INDIANA DEPARTMENT OF TRANSPORTATION

STANDARDS COMMITTEE MEETING

June 18, 2009 Standards Committee Meeting

RE: Agenda for the June 18, 2009 Standards Committee Meeting

615-SMON-02 Survey-Monument Sign

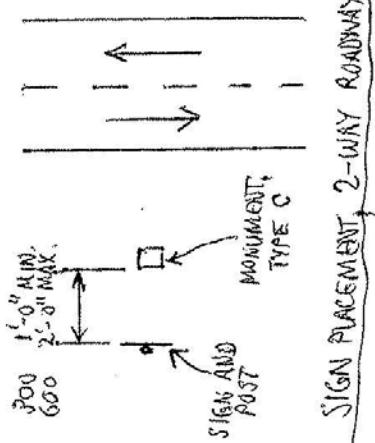
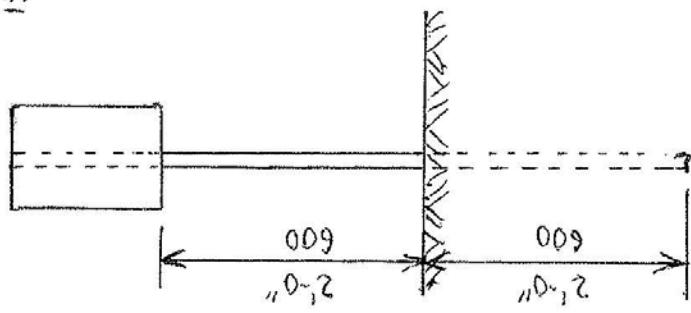
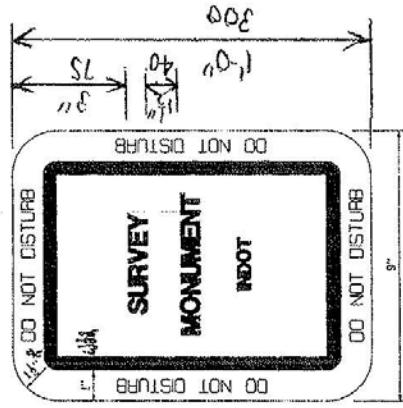
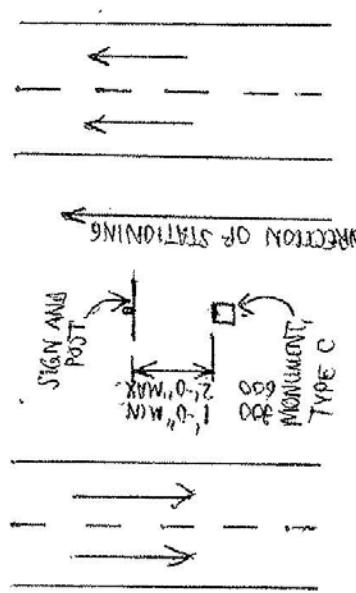
The standard documents are silent regarding placement, method of measurement, and basis of payment for a "Survey Monument INDOT" sign, now detailed in the Standard Drawings.

PROPOSED SOLUTION: Identify the monument-pin material only in the Standard Specifications. Develop a new standard drawing showing placement requirements for the "Survey Monument INDOT" sign. Move, delete, add materials-related and construction-related requirements in the proper Standard Specifications sections as required. Include method-of-measurement and basis-of-payment requirements for the survey-monument sign in the Standard Specifications. Develop a technical advisory which indicates to designers that the sign requirement should be shown on the plans. Show editorial corrections on all monument-related Standard Drawings. Re-identify them as one 615-SMON series.

The survey-monument-sign placement details become new 615-SMON-02

The backing material for "Survey Monument INDOT" signs shall be in accordance with 919.01(a)1. Sheeting shall be in accordance with 919.01(b)2. The posts shall be type A in accordance with 910.14(a), or wood in accordance with 911.02(e).

Right-of-way markers, reset right-of-way markers, monuments, re-established monuments, castings adjusted to grade monuments, bench mark posts, and reset bench mark posts will be measured by the number of units installed. Parking barriers will be measured by the number of units installed. *“Survey Monument INDOT” signs and posts will not be measured for payment.*

Survey-line monument type C will require a "Survey Monument INDOT" sign to be placed near the monument. The sign and placement details are shown on the INDOT *Standard Drawings*. The identification to be shown on the Plan and Profile sheet should read, *Monument Type C and Survey-Monument Sign Required*. If monument types and locations are summarized in a table, the requirement for the sign should be included.

<u>SECTION - CORNER MONUMENTS</u>							
APRIL 1995	<u>SMON-03</u>						
STANDARD DRAWING NO. E 615-SCMON-01							
DETAILS PLACED IN THIS FORMAT 11-95-99

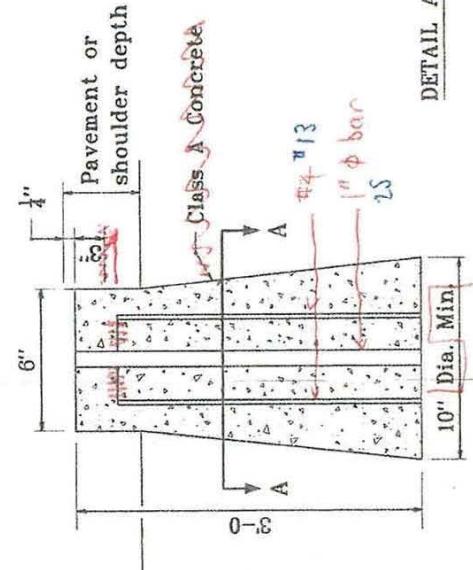
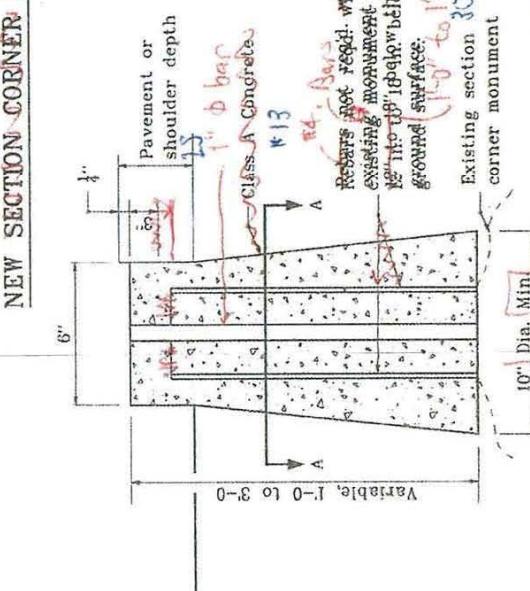
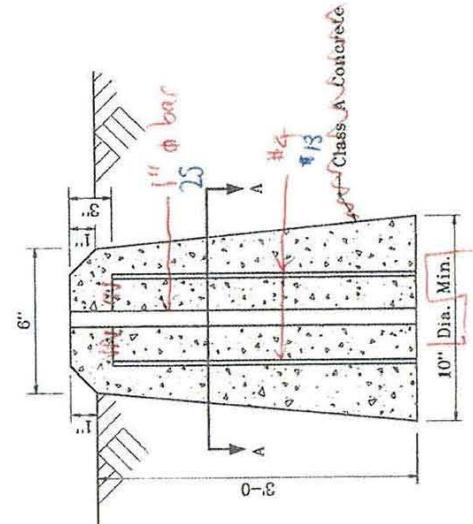
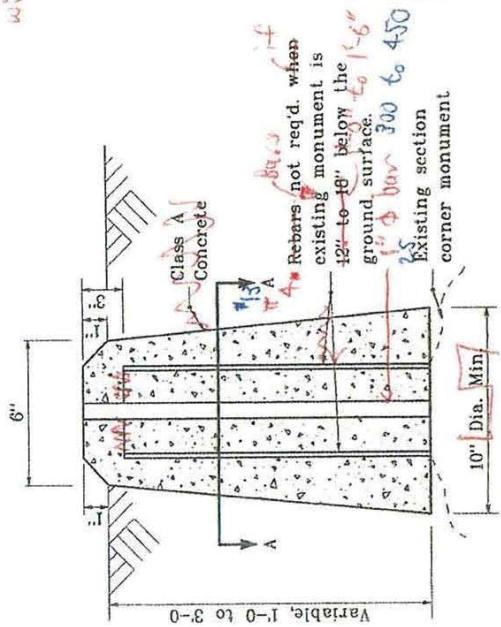
The Standard Drawings regarding monuments require editorial corrections for consistency and clarity.

Current 615-SCMN-01 becomes new 615-SMON-03

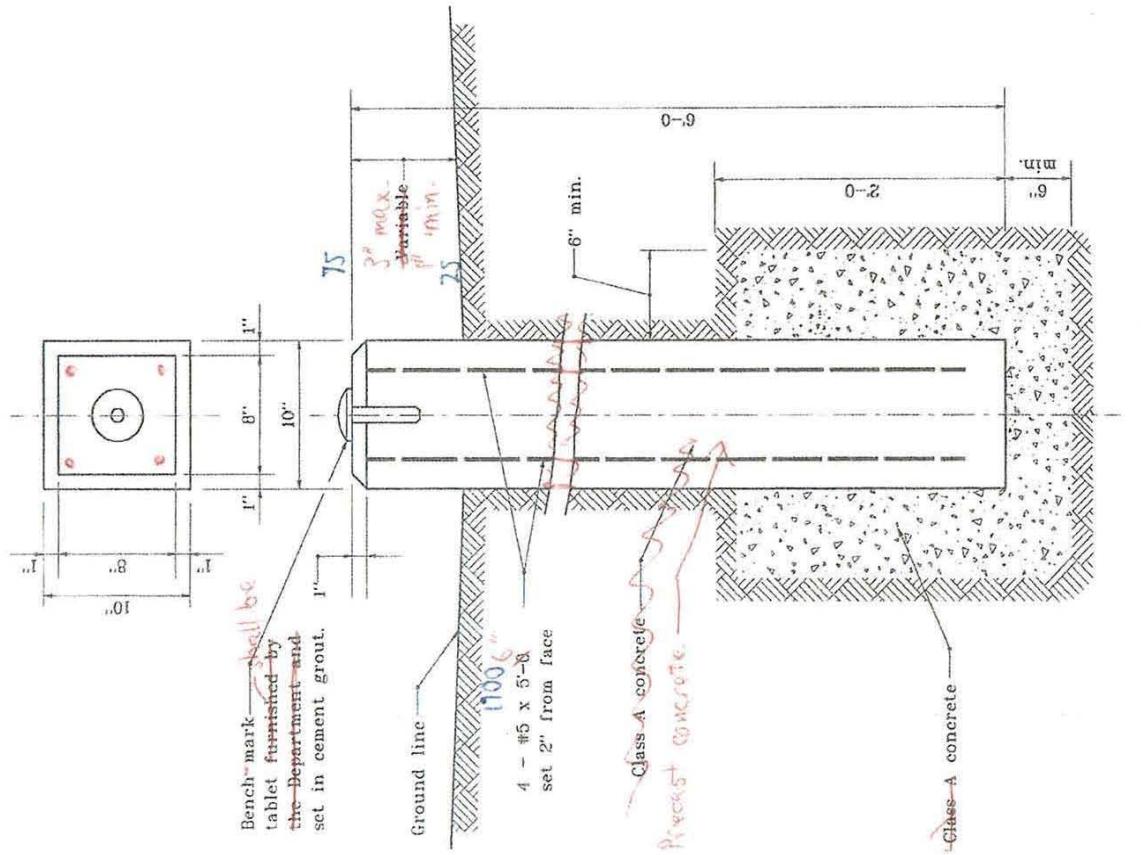
Current 615-SLBM-01 becomes new 615-SMON-04.
